**Ceramic Grill Holder in compact microwaves ovens
Production after week 15/2008**

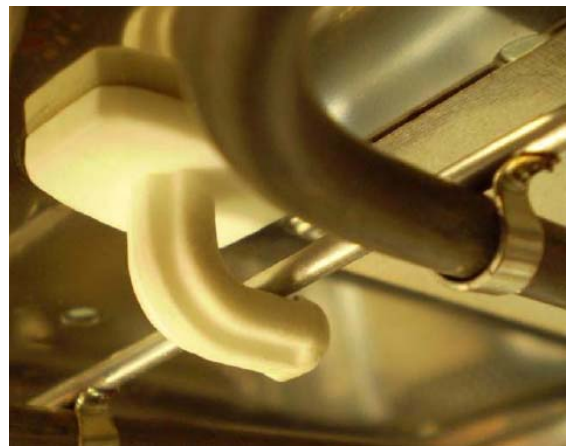
This new system brings the following improvements:

- Easier replacement during service (it is not necessary to uninstall de microwave oven).
- Only one part (the metallic washer that fixed the older ceramic is not used anymore).
- Easier cleaning of the ceramic support (can be removed for washing).

Nwe ceramic holder
held in place by its own configuratoin after insertion
on a special shaped hole and a 90° rotation.

New ceramic holder just before being inserted in a special shaped hole.

New ceramic holder after insertion in the special shaped hole and 90° rotation.

The new ceramic holder isn't it interchangeable on microwave ovens on the market, produced before week 15/2008.
